To: Brookline Planning Board

From: Brookline Planning Department Staff

Subject: Construct a two-car parking area at the rear, instead of previously approved four car garage

Location: 1471 Beacon Street

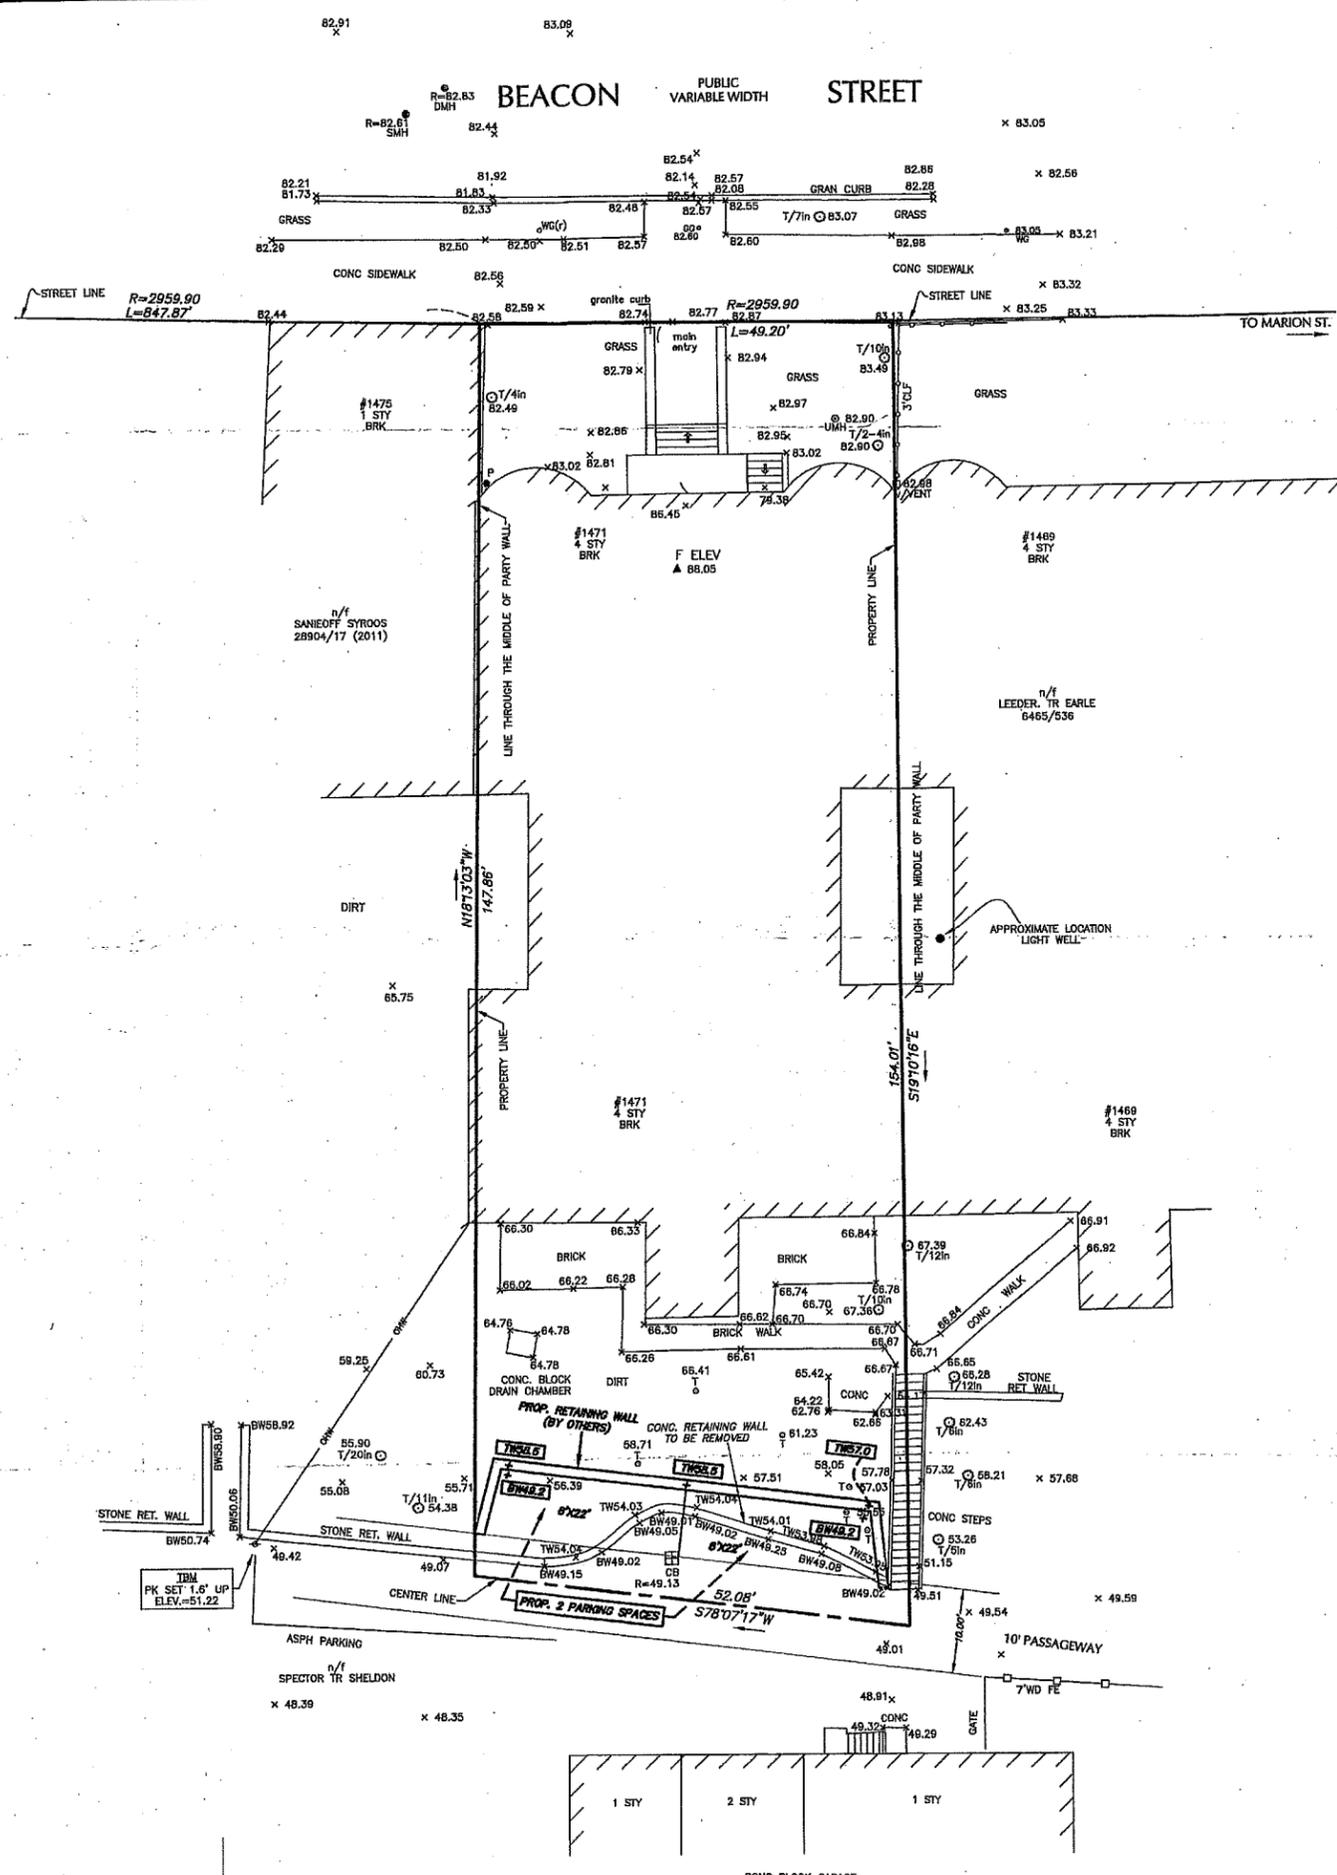
Therefore, the Planning Board recommends approval of the site parking plans by J.F Hennessy Co. dated 6/27/16, subject to the following conditions:

1. Prior to the issuance of a building permit, the applicant shall submit final plans and elevations, subject to the review and approval of the Assistant Director of Regulatory Planning.

2. Prior to the issuance of a building permit, the applicant shall submit a final landscape plan, stamped and signed by a registered landscape architect, indicating substantial counterbalancing amenities, subject to the review and approval of the Assistant Director of Regulatory Planning.
3. Prior to the issuance of a building permit, the applicant shall submit to the Building Commissioner for review and approval for conformance to the Board of Appeals decision: 1) a final site plan stamped and signed by a registered engineer or land surveyor; 2) final elevations stamped and signed by a registered architect; and 3) evidence that the Board of Appeals decision has been recorded at the Registry of Deeds.
